**Appeal Submittal:
City of Key West, FL
Appeal of FEMA's Preliminary Flood Insurance Rate Maps
and Flood Insurance Study
(issued 12/27/2019)**

May 2021

Prepared for:
City of Key West
1300 White Street
Key West, FL 33040

Prepared by:
Woods Hole Group
A CLS Company
107 Waterhouse Road
Bourne, MA 02532 USA
(508) 540-8080

Figure 2. FEMA Figure 5.1 from IDS 1 Section 5 (annotated to show Key West)

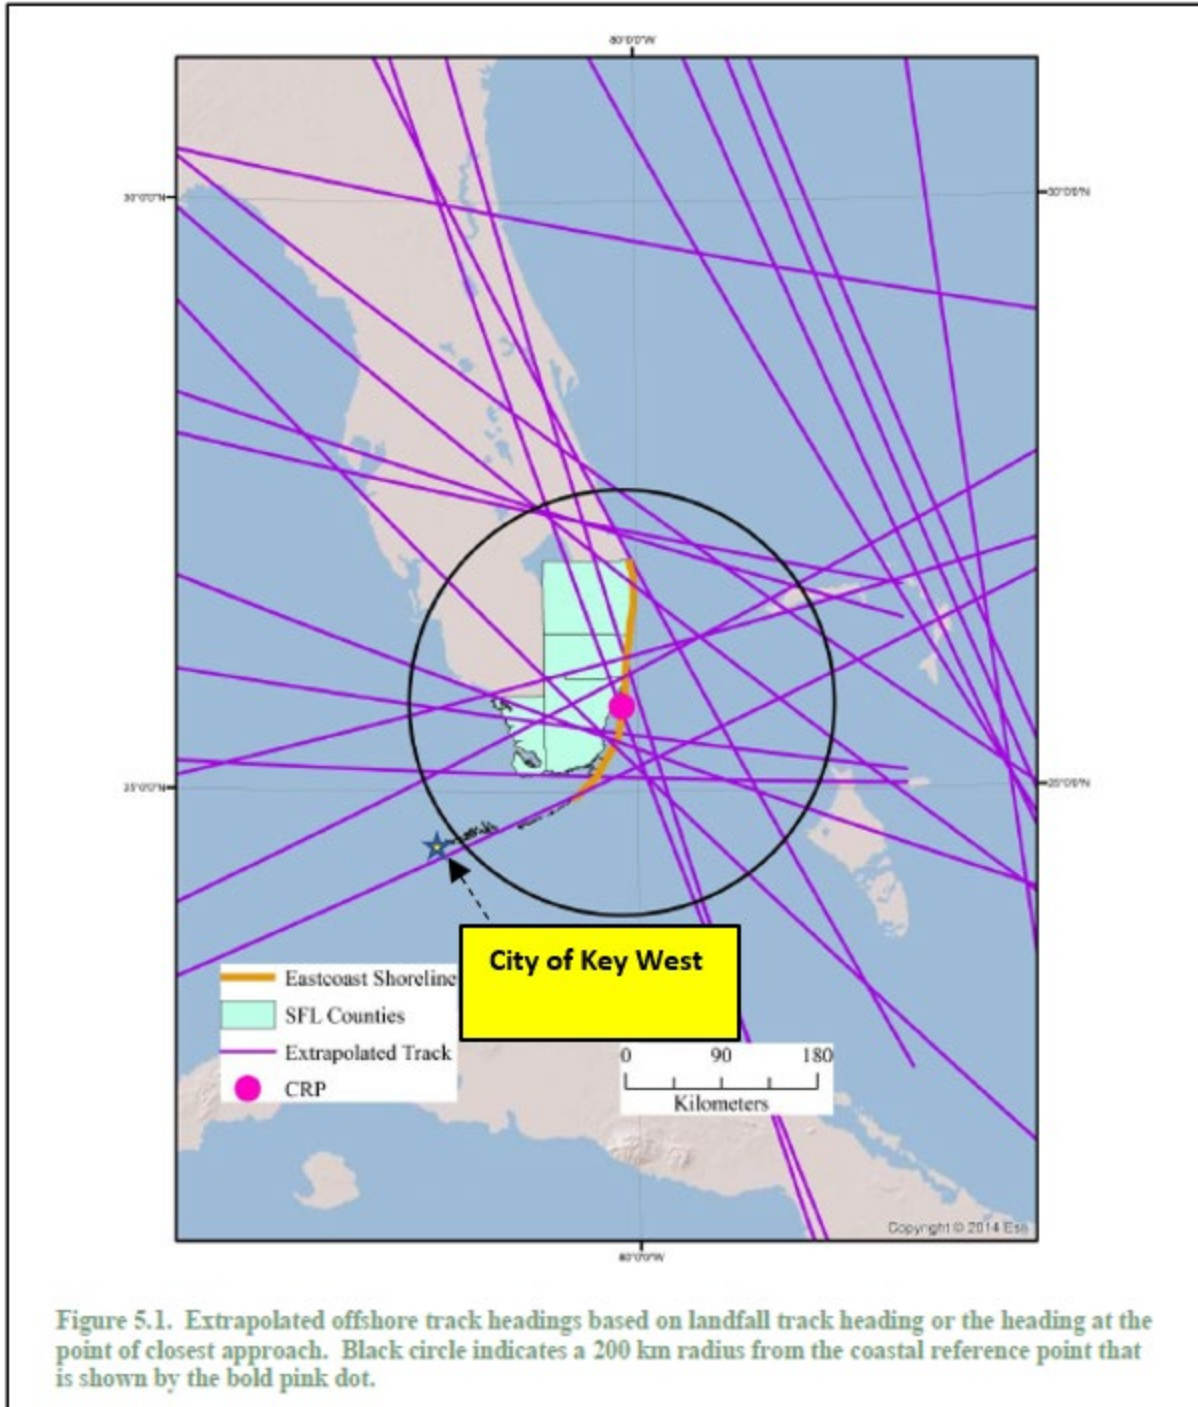
The CRP used by FEMA is shown in Figure 2 along with extrapolated offshore tracks for historical storms based on the landfall track heading or heading at the point of closest approach. Also shown in this figure is the 200 km radius from the CRP which is used in the calculations to define storm rates. This figure also denotes the City of Key West which is located outside of this 200 km radius. This clearly indicates FEMA’s calculated storm rates (dependent on distance from the CRP) are more appropriate for Miami-Dade, Broward, and Palm Beach counties. If FEMA used a CRP at a more central location for the Florida Keys (i.e., City of Marathon), the analysis of storm rates would certainly produce different results which would be more applicable for Key West.

Figure 3. FEMA Figure 5.4 from IDS 1 Section 5 (annotated to show difference in storm rate at heading = -50 deg)

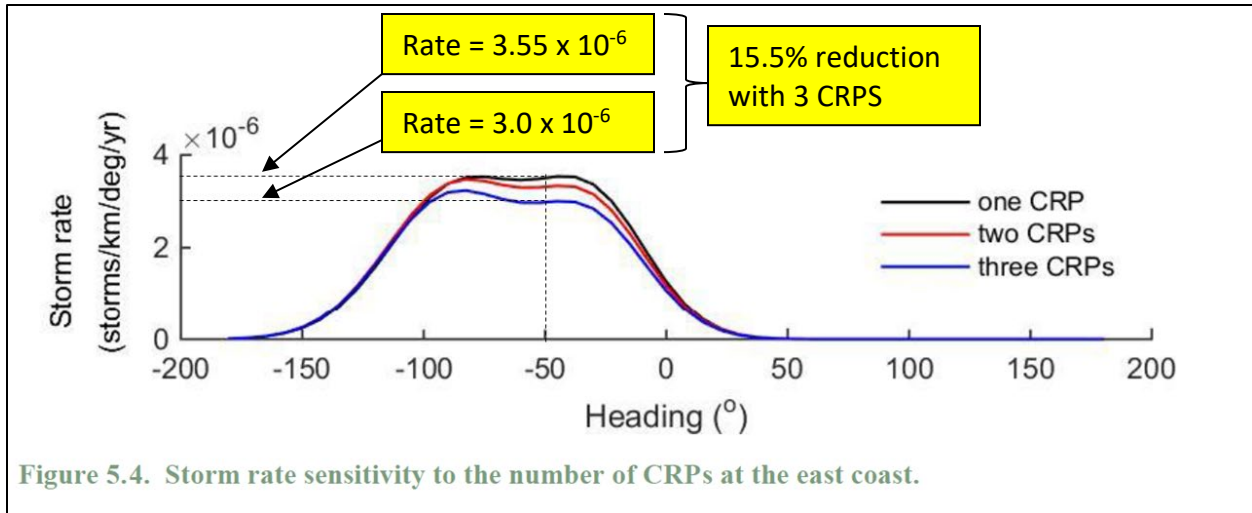
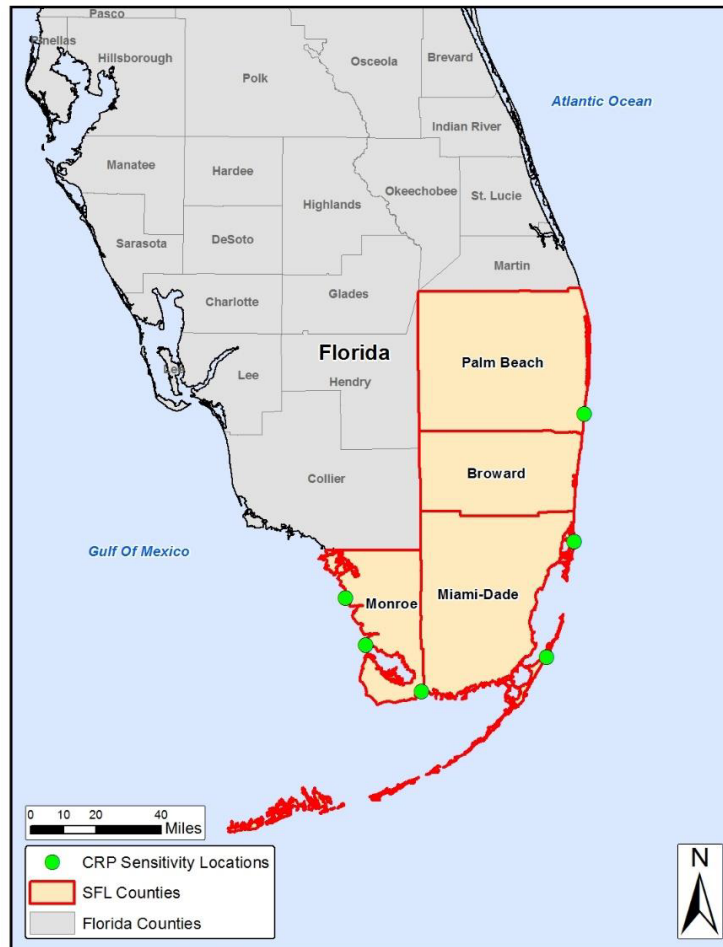
In FEMA’s Intermediate Data Submittal (IDS) Report 1 Section 5, there is discussion of a sensitivity analysis FEMA conducted using multiple CRPs. This analysis showed the use of multiple, spatially distributed CRPs produced lower storm rates, however FEMA decided to use only the one CRP stating that “*one CRP results in a slightly higher rate and is a more conservative choice*”. Figure 3 (FEMA’s Figure 5.4 from IDS 1 Section 5 with annotations) shows the results of FEMA’s analysis and the sensitivity of storm rate to the number of CRPs. This illustrates that the difference in storm rate between 1 and 3 CRPs is not insignificant. For example, with 3 CRPs the storm rate is reduced by greater than 15% for storms with a heading of -50 degrees. This indicates that a more robust approach would result in more correct evaluation of the storm characterization.

Figure 5. Example FEMA production synthetic storm tracks that interacted with land masses but did not include attenuation due to this interaction.

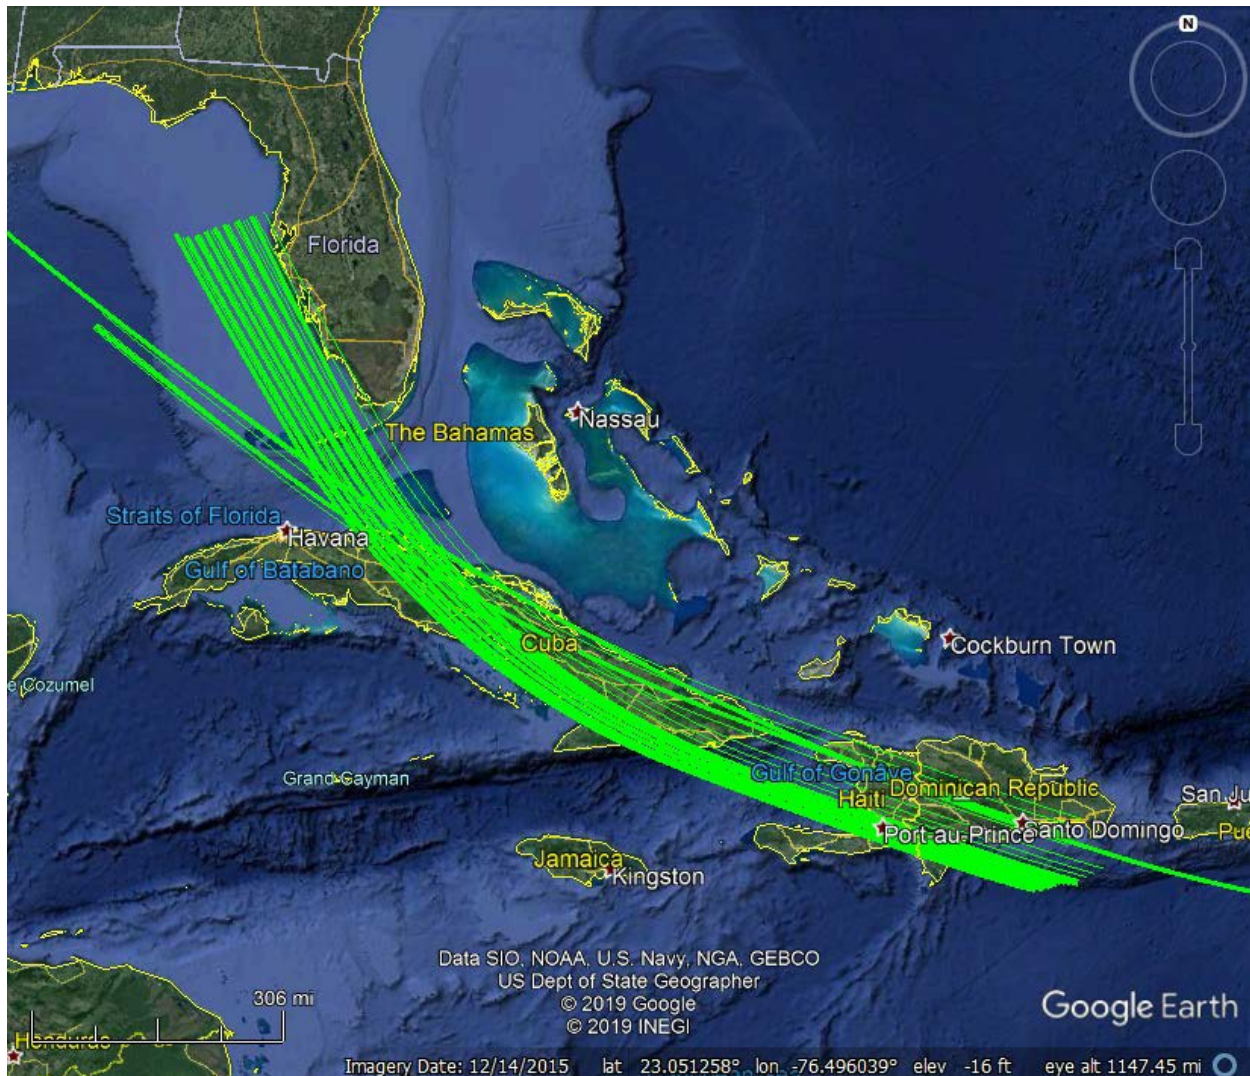
This implicit treatment of the Keys points to the single CRP issue previously discussed and the replication of storm tracks introduced another concern. FEMA characterized the historical storm climatology using a CRP on the Florida mainland. Many of the historical storms impacting the mainland did not have any significant interaction with land masses (i.e., Hurricane Andrew). FEMA then used the historical storm climatology for the development of the production synthetic storms. This led to the development of synthetic storms appropriate for the mainland and these storm tracks were then replicated south down through the Florida Keys. The synthetic storm tracks replicated across the Keys then crossed over significant land masses where typically there is attenuation of the storm’s intensity (based on recorded historical storms such as David (1979), Georges (1998), and Irma (2017)).

Figure 5 shows a sample of FEMA’s replicated synthetic storm tracks and a review of these synthetic storms showed there was no attenuation (or decrease in storm intensity) due to the interaction with Cuba and other land masses. Out of the 392 synthetic production storms, 72 storms pass over the long axis of Cuba (33 making landfall on the east coast and 39 making landfall on the west coast).

The combination of developing storms better suited for the mainland, replicating those storms across the Keys, and then not including storm attenuation due to interactions with land masses led to a scientifically incorrect characterization of flood hazard in the Keys.

The fact that the synthetic storms did not include attenuation caused by land masses was not addressed and would have exceeded the City’s study capacity and time constraints to resolve. Through the determination of the spatially varied storm rates and their application, the frequency of storm impacts in the Keys was more accurately assessed.

Figure 7. Time series comparison of NOAA-observed wave conditions during Hurricane Andrew with FEMA's modeled conditions at NDBC station 42025.

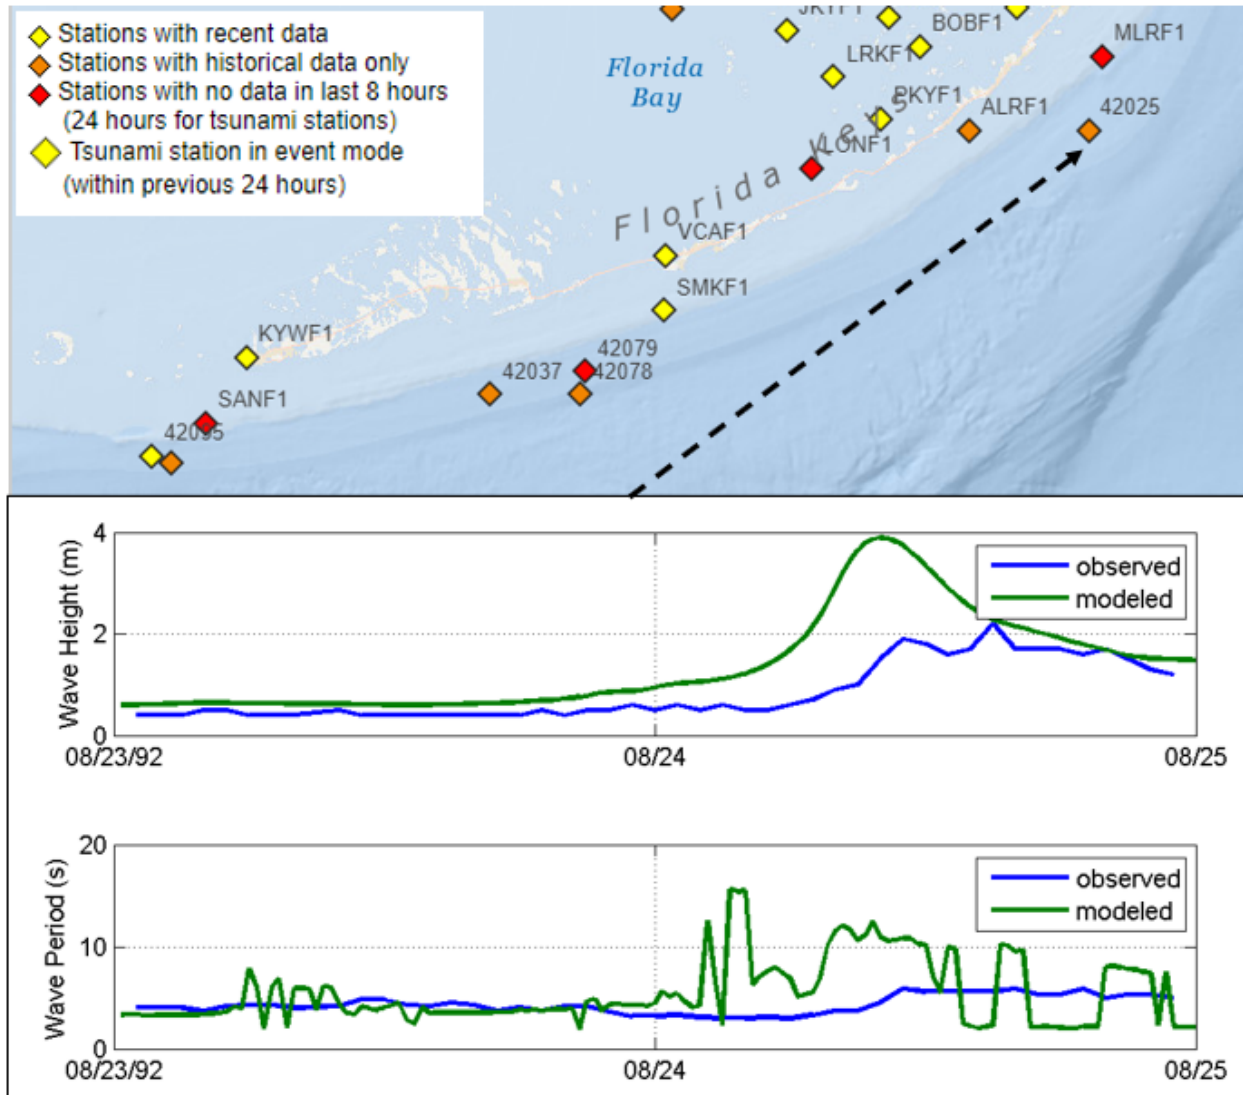
Additionally, FEMA could have elected to collect wave measurements over the course of the multi-year study. This is the only FEMA coastal study in which there has been no wave data for the purposes of model validation and the only FEMA study the City’s team is aware of that has been performed without wave model validation.

Again, this indicates a lack of sufficient or poor-quality data in order to determine whether output from the wave model is technically incorrect.

A comparison was made between wave data measured at NOAA’s NDBC buoy 42025 during Hurricane Andrew and FEMA’s model output from its model hindcast of Hurricane Andrew, as shown in Figure 7. It shows FEMA’s model overpredicts the wave height at this location by approximately 2 meters (6.5 feet). This comparison does not provide confidence in the model’s ability to predict wave conditions.

The lack of wave model validation was not addressed through additional reanalysis. The acquisition of additional storm wind and pressure fields and additional model validation would require additional funds and time that went beyond what could be accommodated by the City in this appeal.

Figure 8. Example of lack of sufficient model resolution – Fleming Key Cut. Panel (a) shows aerial image and panel (b) shows the model mesh overlaid on color contours of elevation (yellow to red colors represent overland areas > 0 ft in elevation relative to NAVD88).

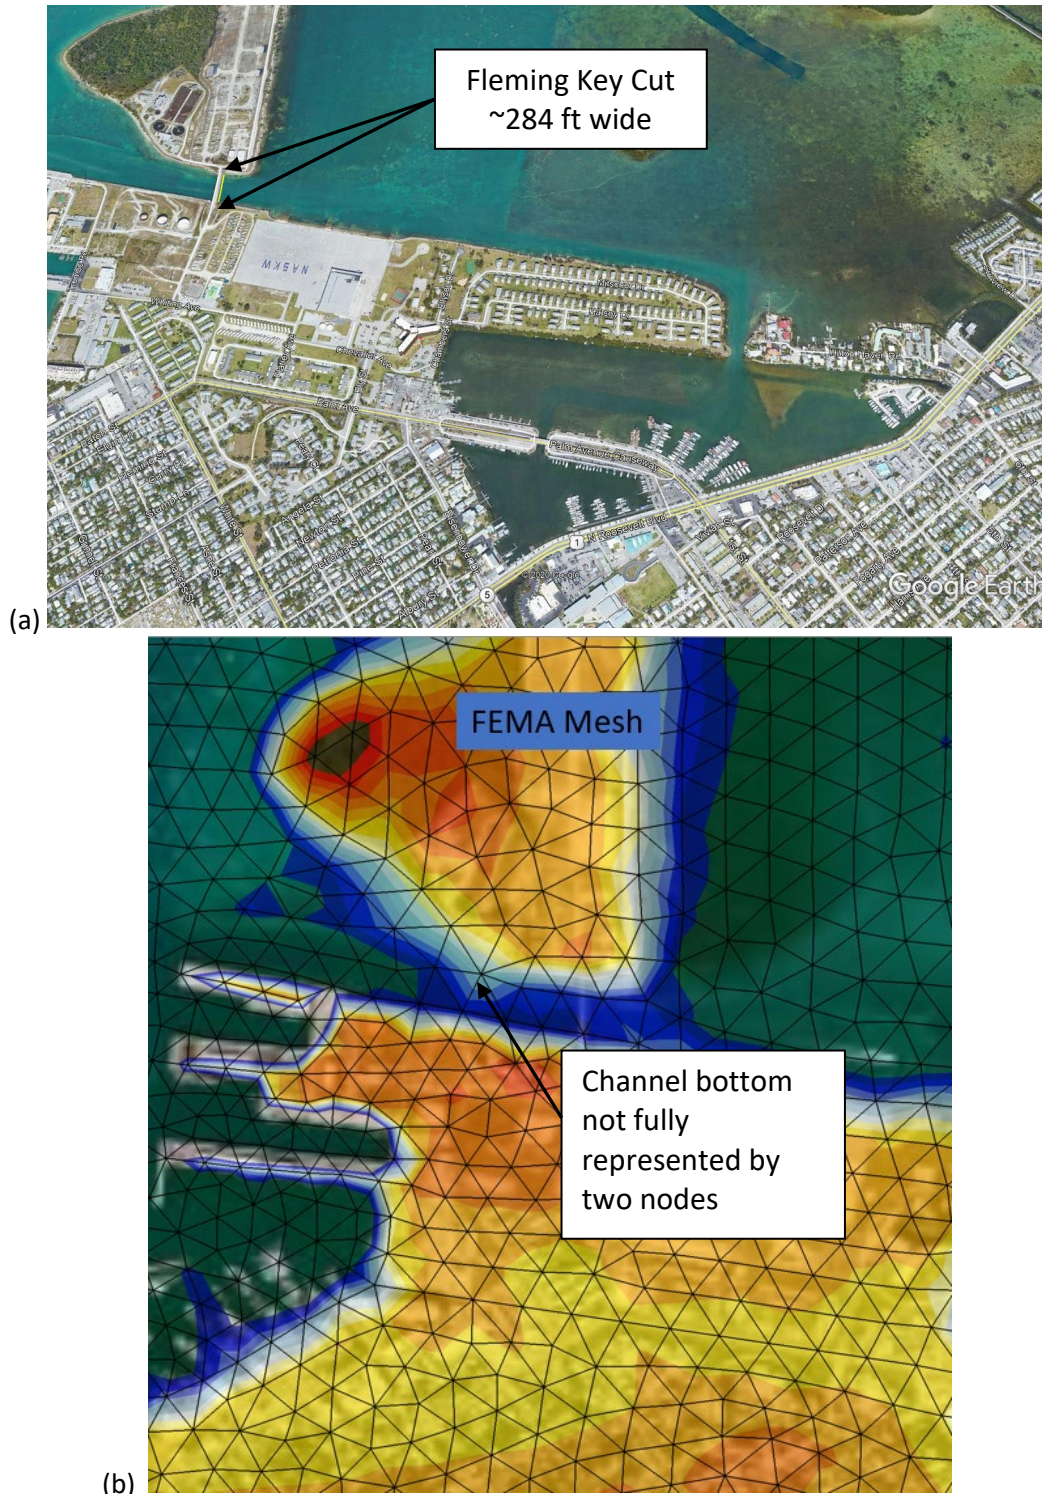
Issues related to the ADCIRC+SWAN hydrodynamic/wave model mesh were identified at seven (7) channel locations throughout the Keys. The model mesh was not resolved to sufficiently represent the hydraulic capacity of the channels and allow conveyance of storm surge and waves during simulated storms. These were errors or oversights made in the mesh developed for the Keys. This issue was communicated to FEMA in correspondence dated May 4, 2020. FEMA responded in their June 11, 2020 correspondence that these were not errors but rather the modelers chose to not fully represent these channels because the target mesh resolution (distance between model nodes) for the Florida Keys was 250 feet. Additionally, FEMA stated that, “The request to improve conveyance pertains to a higher level of detail analysis that falls outside of current scope of the Flood Study.”

Table 3 lists the seven (7) channels that lacked sufficient resolution in the model along with the channel widths. Figures 8 and 9 show examples of channels in the Keys that were not fully represented (further examples are presented in Appendix A, Attachment B). Most of these channels have widths at or greater than 250 feet, the target resolution. Even if these channels are smaller than the target resolution, consideration should have been given to represent the primary channels in and around the Keys to an appropriate level of resolution to be technically correct in conveying storm surge. The City does not believe this falls outside the scope of FEMA’s study.

As part of the City’s review, the storm surge and wave model resolution was increased where it was found to be insufficient at the channels listed in Table 3. This resulted in only 75 additional nodes added to the model mesh (total of 2,249,168 nodes). A single production storm was first run (storm 113) to assess the potential impacts of the lack of resolution. Storm 113 was selected as it tracked within the middle portion of the Keys and had a substantial contribution to the 1%-annual-chance water levels developed by FEMA. Comparisons with FEMA’s results showed local differences in maximum storm surge on the order of 0.4 to 1.6 feet (see Appendix A, Attachment B for further details). This indicates the importance of adequately resolving these channels, and that FEMA’s model results are scientifically incorrect because the model resolution used was inappropriate.

This issue related to insufficient model resolution and representation of hydraulic pathways was addressed by increasing the storm surge and wave model resolution where it was found to be insufficient. The updated model was revalidated and then used to simulate a subset (46 storms) of FEMA’s defined JPM-OS synthetic storm set. Further details are provided in Appendix A. The results from these storm runs were then incorporated into the statistical analysis of water levels and waves that affect the 1%-annual-chance base flood elevations. Updated overland wave modeling and floodplain mapping were then conducted using these updated 1% wave and water levels, as detailed in Appendix C.
